CITY OF DALLAS

LANDMARK COMMISSION

Monday, March 7, 2022

AGENDA

Figure 8 – Previously Approved Rear Elevation (openings to be removed highlighted above)

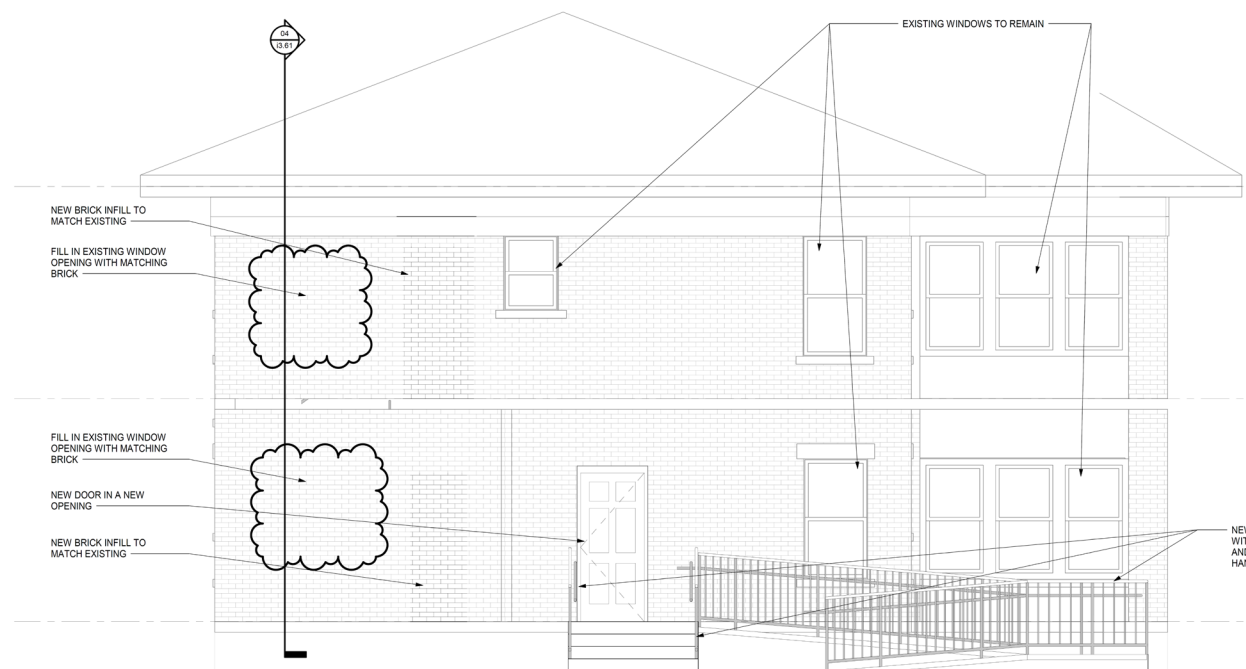
The addition will match the design and materials found on the original structure (Figures 2, 6-10), including the reuse of the original paired window (Figures 9, 10) on the rear facade. This sensitivity to the original architecture further minimizes any potential impact of the new construction that may be seen from adjacent properties as well. The sizable recess from the side elevation (Figure 13) sets this apart as a clear addition. With the retention of the original paired window, in theory, the building could be returned to its original configuration with little effort.

Figure 15 - Applicant submitted description of work keyed to the description on the following page. Only items 8, 10, and 11 are under consideration by the Landmark Commission under this CA. The remainder are addressed as routine items.

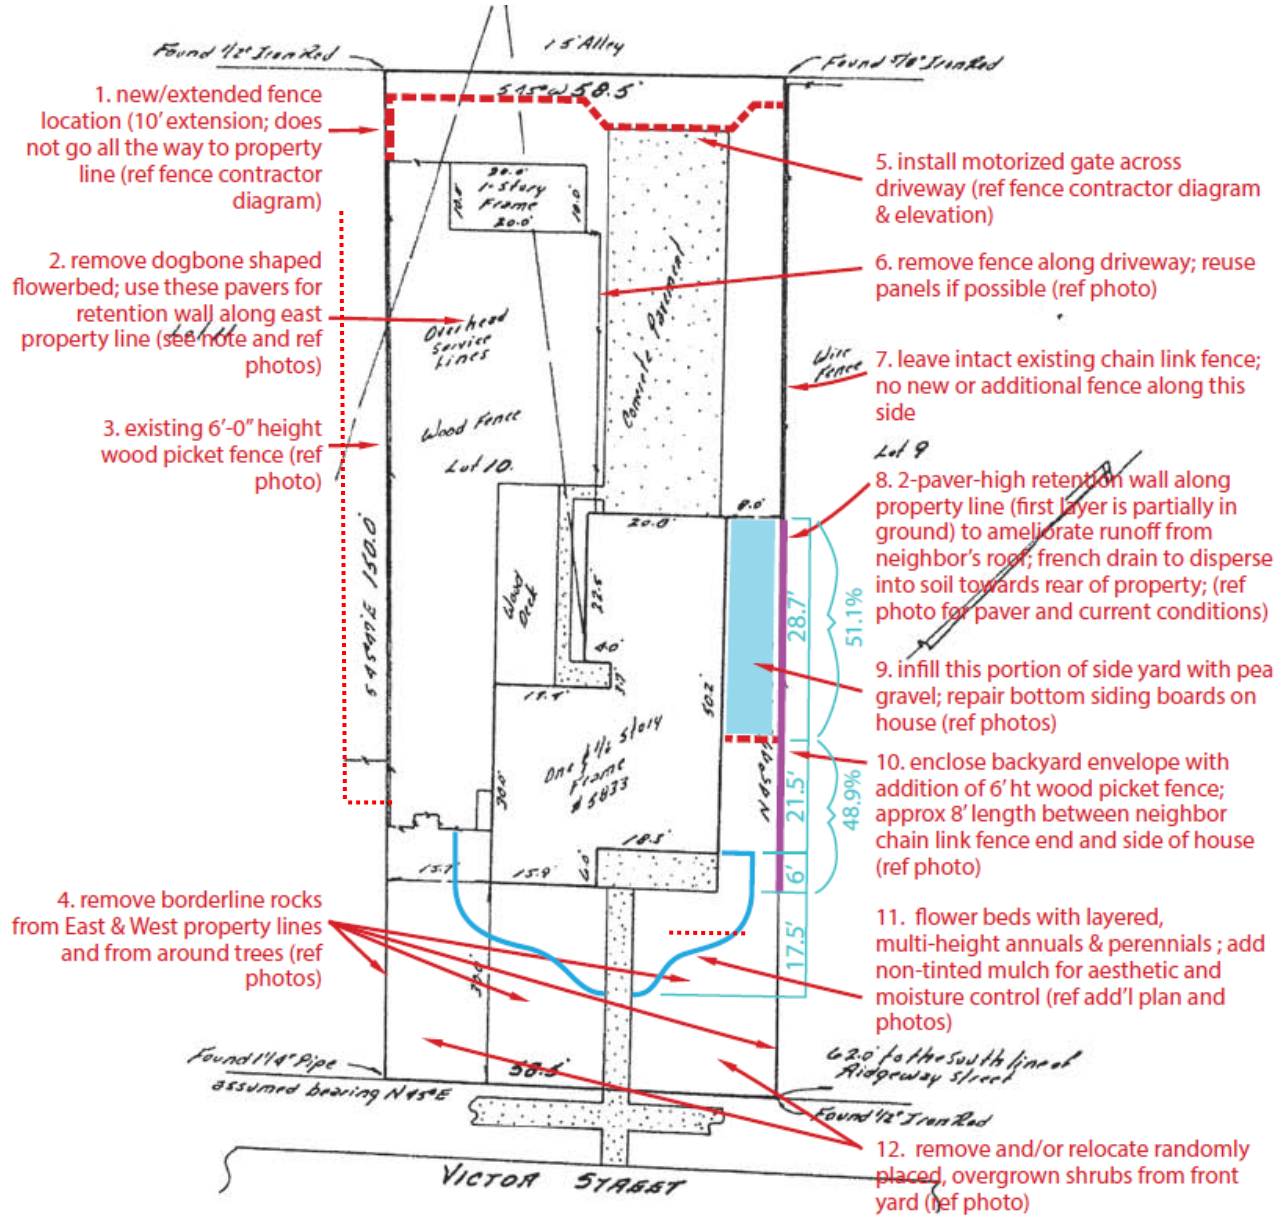
The applicant is requesting a simple retaining wall (Figure 15) as part of a larger effort to address significant surface water issue that is a result of the existing grade of the lot and runoff from the adjacent property. The subject property lies lower than the adjacent lot (Figure 7), which is likely the result of this lot being leveled for a new slab foundation in the early 1980s. The nearest house also sits close to the property line and all downspouts drain on to the subject property, and this “retaining wall” is an effort to at least minimize the impact and erosion that drainage causes (Figures 9-12) in this area. There is already a section of paver in place (Figures 10 and 14) from prior efforts to address the issue.

It is apparent that some type of intervention is needed to protect the subject property and the proposal appears to Staff to be a measured approach. The paver “wall” will be minimally visible and most people walking by will not even notice it thanks to existing plantings (Figure 12) and the close proximity of the two houses. This “wall” is also easily reversible and could be dismantled in a matter of minutes, further minimizing the potential impact to the district.

Figure 8 – Elevation drawings and attic floor plan

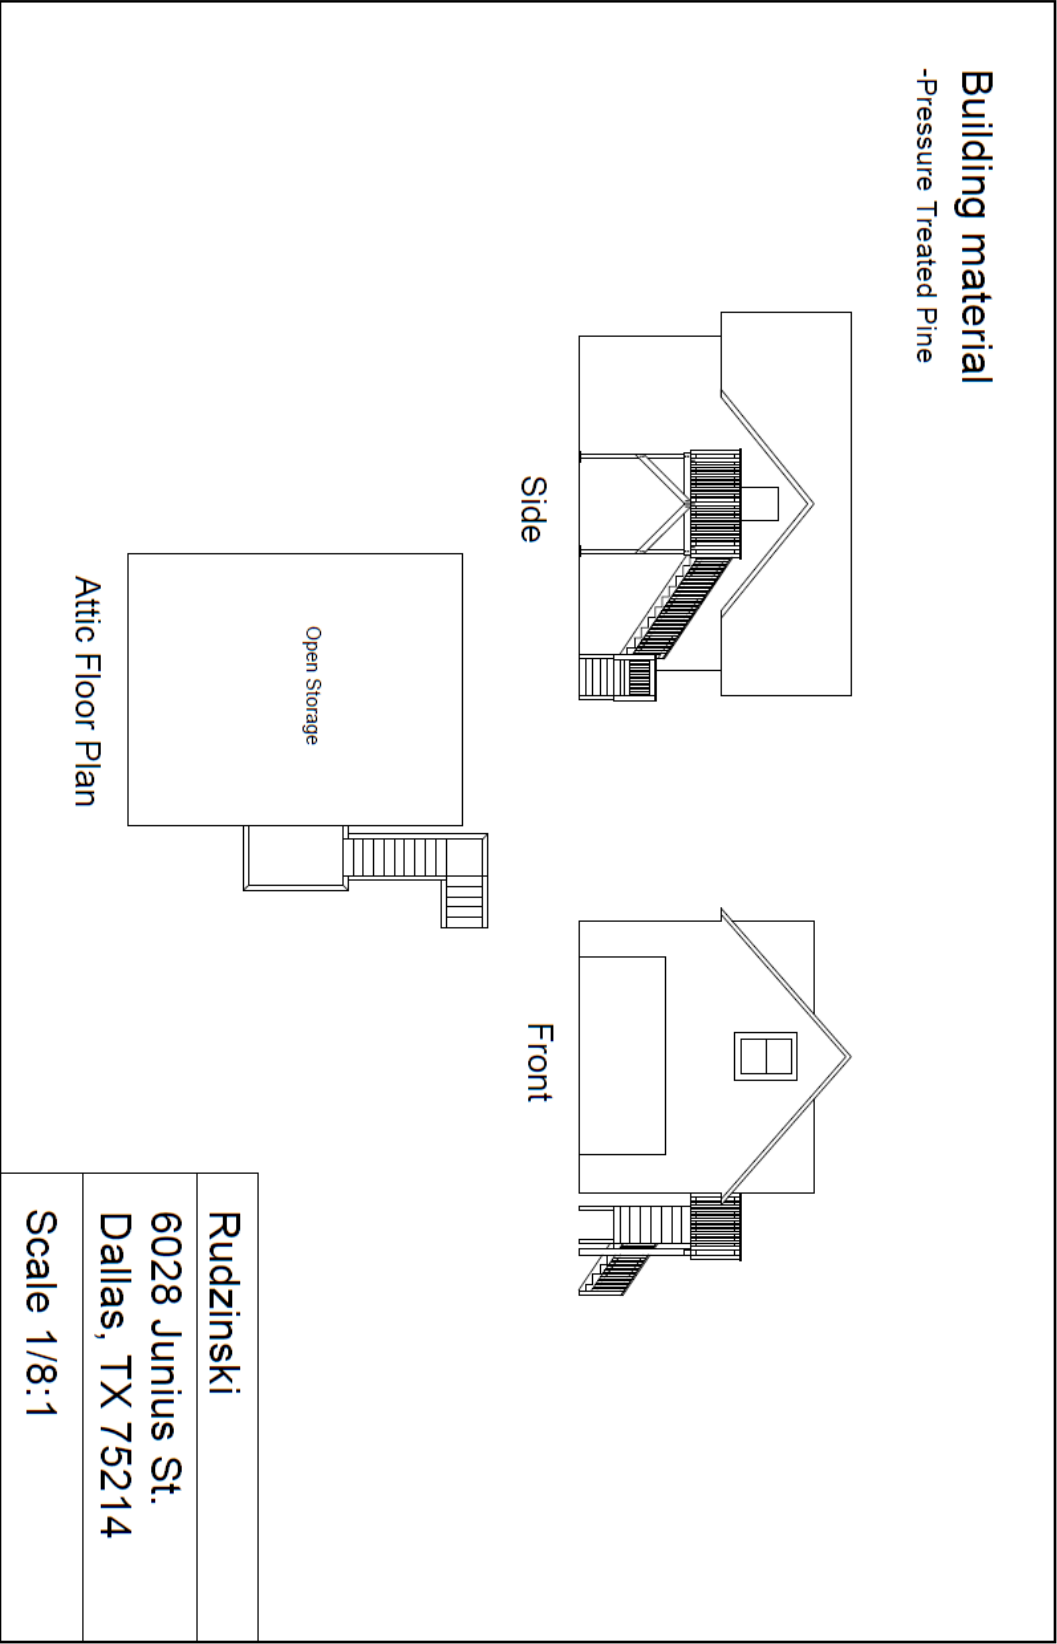
The applicant is submitting the request to add the stair (Figures 7 and 8) to the elevated deck approved by Landmark Commission in the January meeting since a building permit is required and this was something they intended to do down the line. The design and materials of the new stair is consistent with exterior steps found on original garages from the 1920's and 30's. Original garages with living quarters above were once common, so the addition of the stair to this accessory garage is more in keeping with the character of the area than a small deck or balcony, which was previously approved.

The new stair may be visible from Junius Street (Figure 11), but the overall visual impact to the district will be minimal, and as stated previously is what the average passerby would expect to see from a living quarter above a garage in a historic neighborhood. It is important to note that the applicant calls out the space above the garage is to be used for attic storage (Figure 8).

Figure 9 – Elevations of proposed screened porch

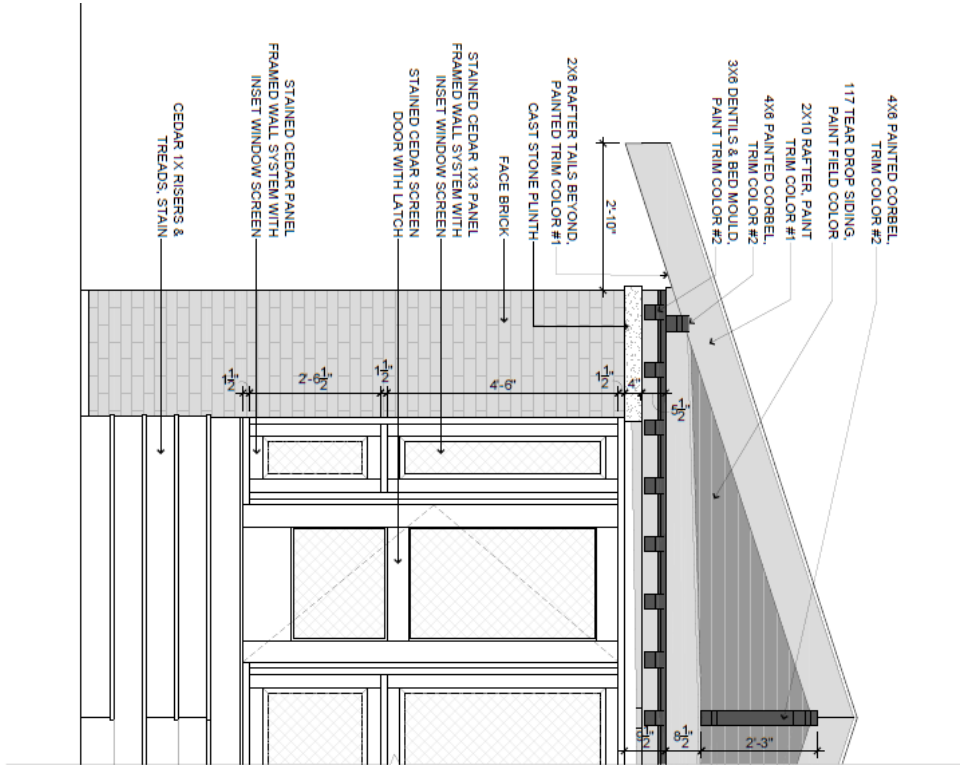
The proposed screened porch addition is compatible with the existing structure but is discernable as a later addition due to the details that nod to original architecture without being a copy. Most notable are the brick columns (Figure 2) and rafter tails which are similar to those found on the main house but with notable differences. The brick used for the new columns (Figure 10) is a close color match but the texture and spotting is just different enough to show this as a different period of construction. The new columns are also lacking the corbels found beneath the cap of the massive front porch columns. Original rafter tails are notched on the end (Figure 6), while the addition (Figures 9 and 10) will have a squared off end as another differentiating design element to set the new construction apart. Elements such as the brackets, dentils, and bed molding carried over from the front porch help to tie the new construction to the old.

Figure 10 – Enlarged detail and materials to be used

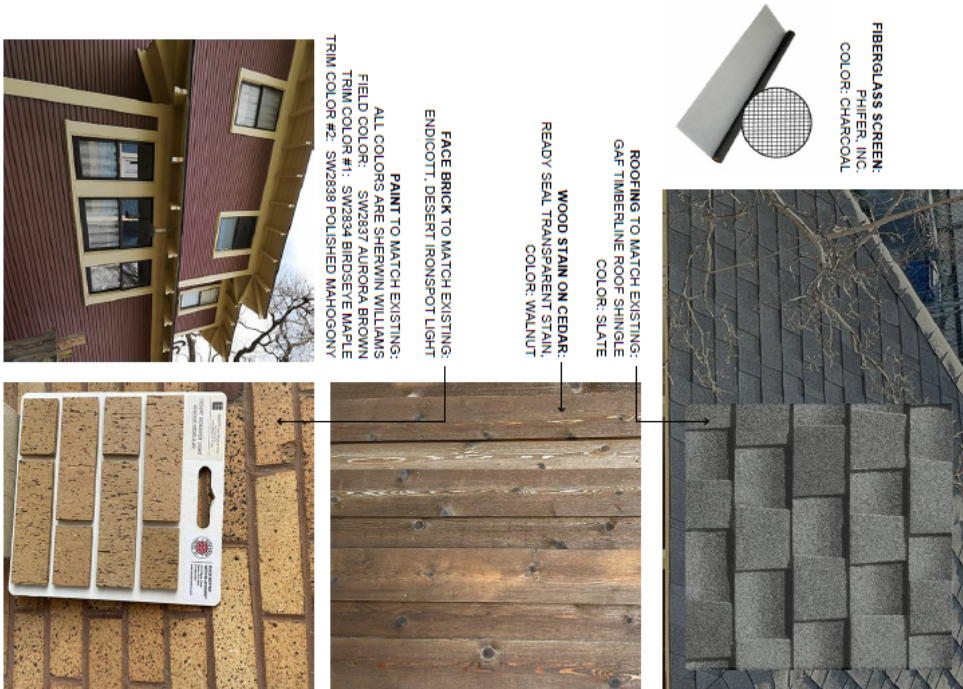
The fiberglass screen and stained wood panels (Figure 10) are another significant differentiating design element setting the addition apart from the original house. While these design decisions would not be appropriate on a front or highly visible elevation, they are perfectly acceptable on a rear elevation hidden from public view.

Figure 10 – Applicant submitted proposal for solar panel install location

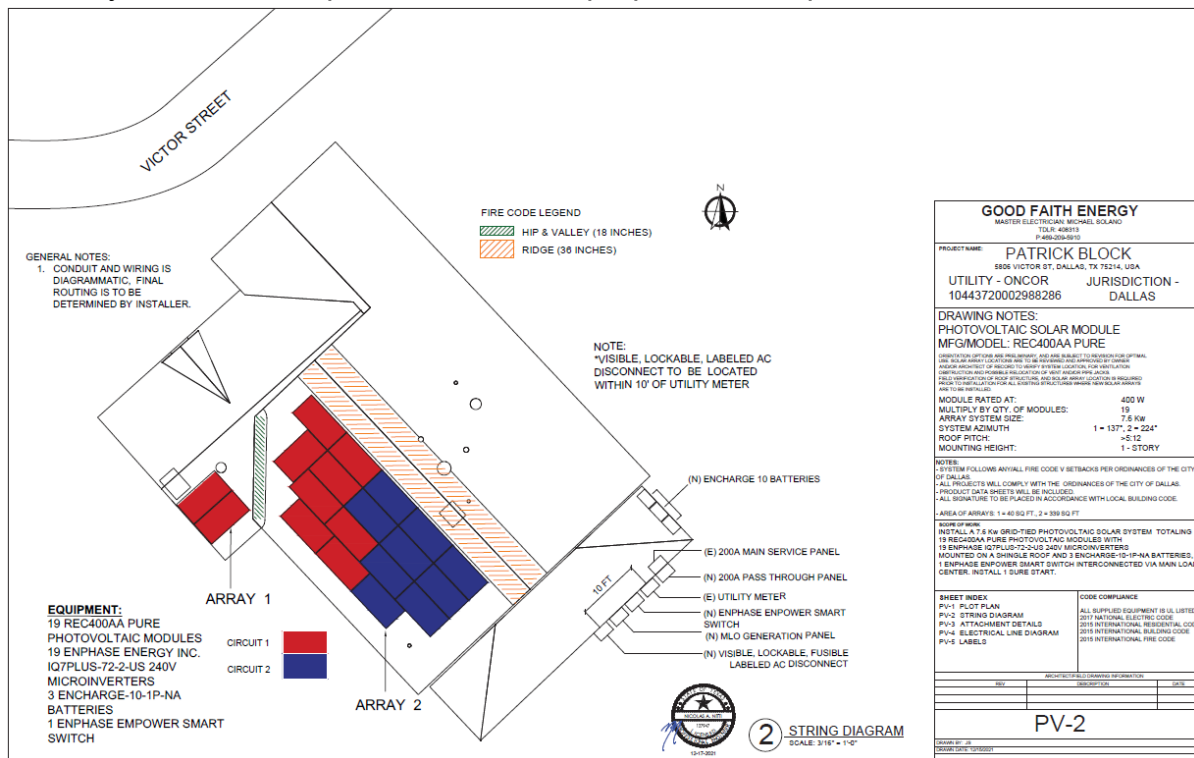
The proposed solar panels (Figures 10-12) take up approximately 80 percent of the south slope of the main roof. This particular area of the roof is visible from the corner of Victor and Abrams (Figure 6), as well as from further down Abrams to the south, and from Lowell Street. The view of this section of roof from Victor St. is somewhat obstructed by the house next door's carport and a tree between the two driveways, although it is still visible. The majority of the south slope of the roof is visible from Lowell St. (Figures 8 and 9) although the roof of the unpermitted accessory structure comes up above the eave of the subject property to partially obstruct the bottom half of the main roof.

1/18/2022
Figure 13 – Detail of proposed gate on wall and entry lighting

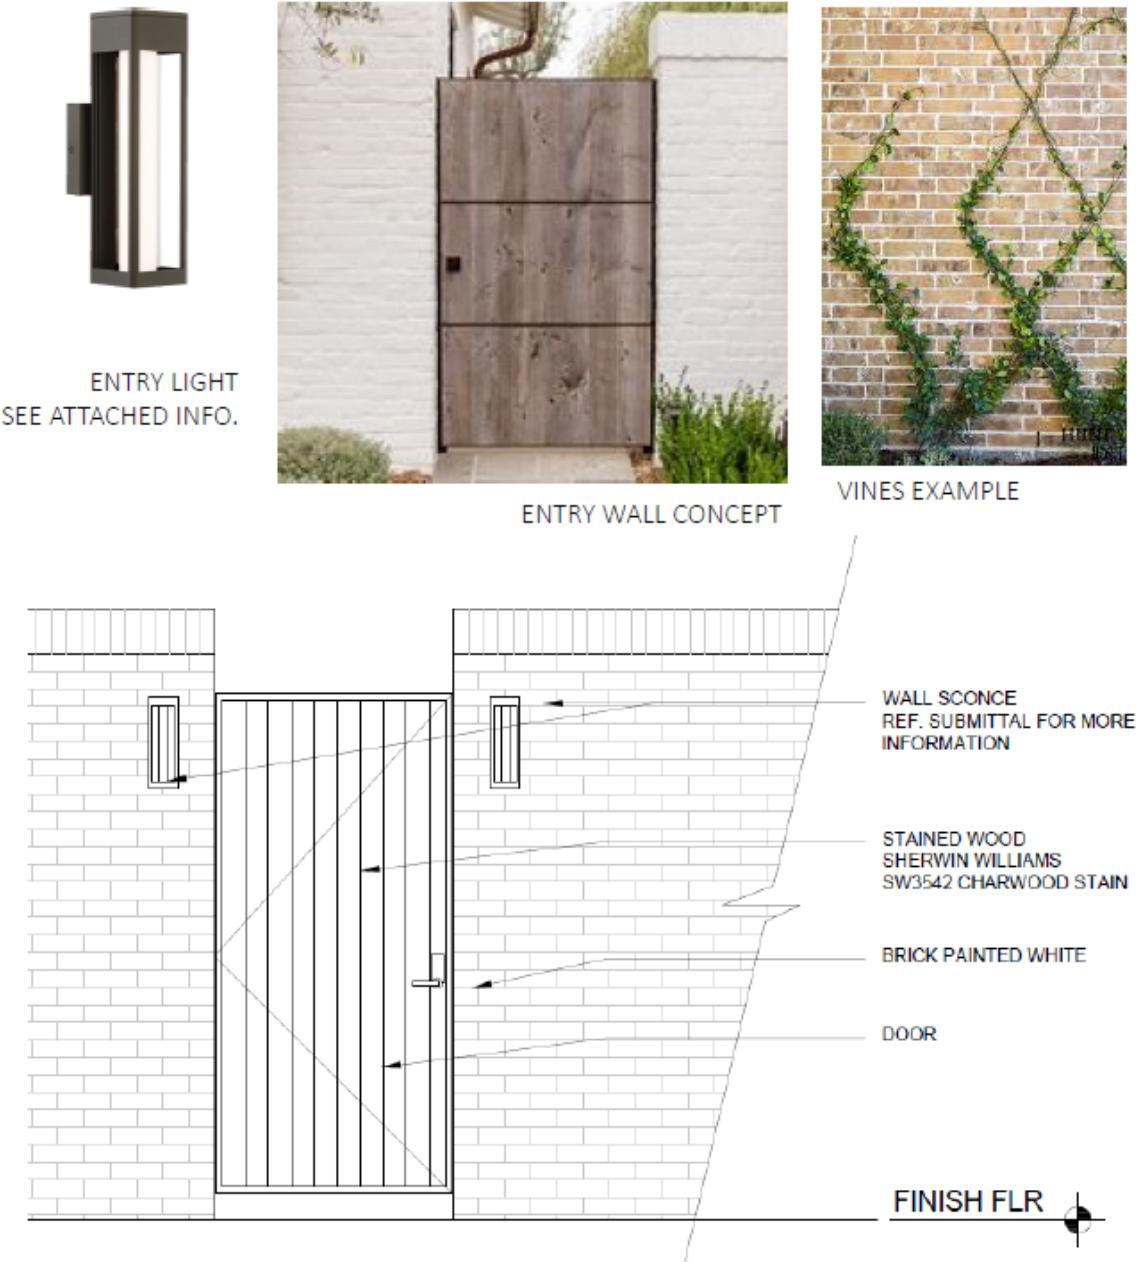
The CMU wall (Figure 13) with brick veneer (Figure 14), as proposed, is problematic for several reasons but is mainly objected to by Task Force and Staff because it is out of character for the age and design of the building. There are several examples (Figure 9) on the adjacent blocks of N. Marsalis that are of similar age and configuration to the subject property that illustrate why it is recommended by Staff and Task Force to deny this new feature. These buildings were designed with a central courtyard to welcome tenants and guests into the complex. There are certainly security concerns, as several have iron fencing enclosing the area including this property, but they do not detract from the original design of the buildings. The proposed wall is essentially a fence in the front yard which the preservation criteria recommends fences in that location be at least 50 percent open. That same section of the ordinance limits the fence height in that location to 3'6", which may not be feasible for this application. A possible compromise could be to utilize architectural breeze block which would allow for screening and security while also being appropriate to the period of construction of the building. An iron fence similar to what is already in place can accomplish this as well.
